Work Order ID 93931

Item Name: Crosstube Turning Detail

DART AEROSPACE LTD	Work Order:	93931
Description: Crosstube Assembly (205/212/412 High Fwd)	Part Number:	D212-664-141
Inspection Dwg: D212-664-141 Rev: D		Page 1 of 2

DRAWING NO. D212-664-141	TITLE XTUBE ASSY (205/212/412 HI FWD)	REV. D	DART AEROSPACE LTD ENGINEERING ORDER		D.E.O. NO. D212-664-141-D-1	SHEET NO. SHEET 1 OF 2	SCALE NTS
DRAWN	CHECKED <i>JP</i>	MFG. APPR. <i>ER</i>	APPROVED <i>WAP</i>	DE APPR. <i>WAP</i>			
DATE 11.04.07	DATE 11.07.11	DATE 11.04.12	DATE 11/04/12	DATE 11.04.12

WALL THICKNESS MEASUREMENT

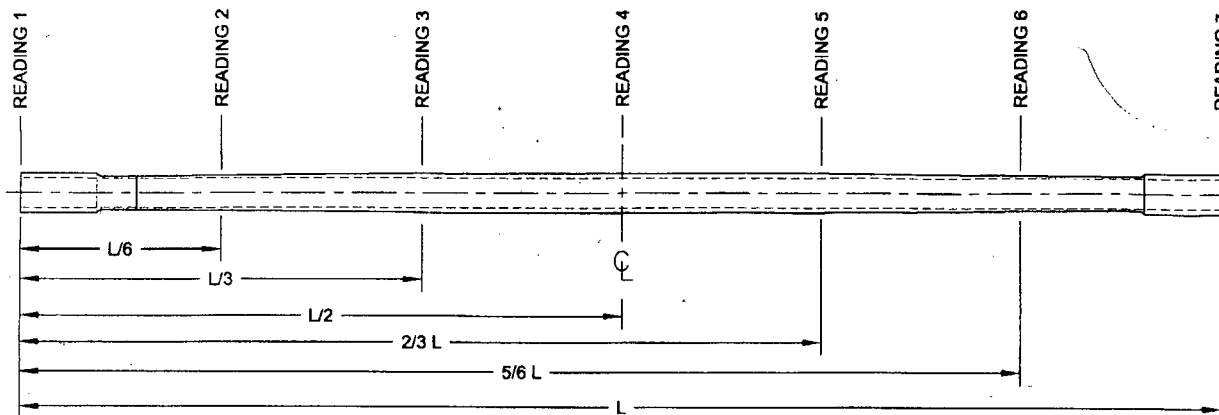
Root Cause	Date	Step	Qty	Description of work order update or Non-conformance	Initial Chief Eng	Action Description	Sign & Date	Verification	QC Inspector
Doc/Data	13/1/15	100	1	Ultrasonic wall measurements are over tolerance.	 13/1/15	Wall thicknesses are within 0.020 of dwg nominal. Acceptable.	 13/1/15	JW 13-1-16	S 13/1/16
Equip/Tooling									
Operator									
Material									
Setup									
Other									
Process									
Supplier									
Training									
Unapproved

**D212-664-141/-141B
ASSEMBLY DETAIL**

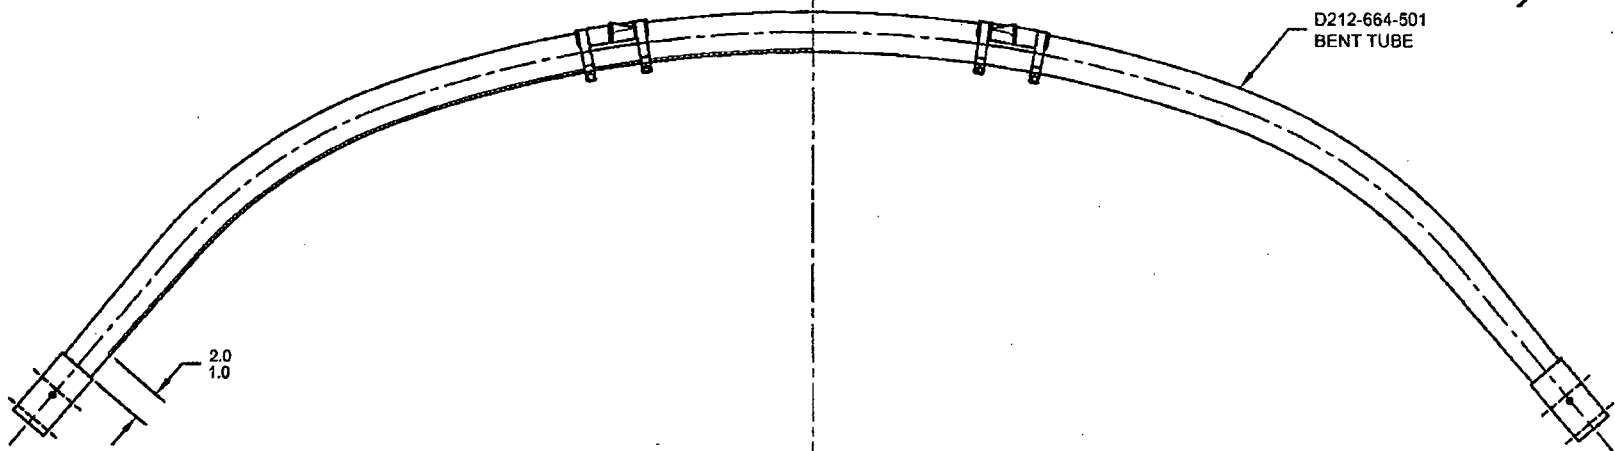
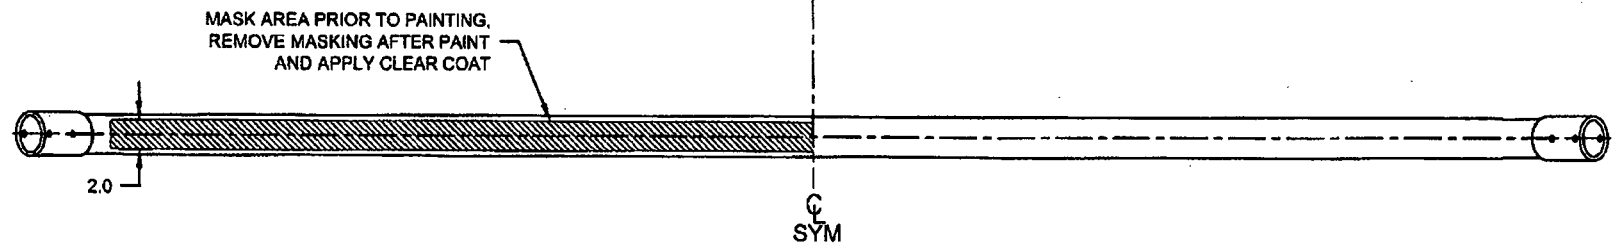
PURPOSE:

ADD AN INSPECTION WINDOW TO UNDERSIDE OF CROSSTUBE.

CHANGE:

NOTES 2 OF SHEET 1 IS AMENDED AS FOLLOWS:

WAS:

- 2) FINISH: CHEMICAL CONVERSION COAT PER DART QSI 005 4.1
PRIME INSIDE AND OUTSIDE PER DART QSI 005 4.2
PAINT OUTSIDE PER DART QSI 005 4.2

IS:

- 2) FINISH: CHEMICAL CONVERSION COAT PER DART QSI 005 4.1
PRIME INSIDE AND OUTSIDE PER DART QSI 005 4.2
MASK UNDERSIDE OF CROSSTUBE AS SHOWN (HATCHED AREA) AND
PAINT OUTSIDE PER DART QSI 005 4.2
REMOVE MASKING AND APPLY CLEAR COAT
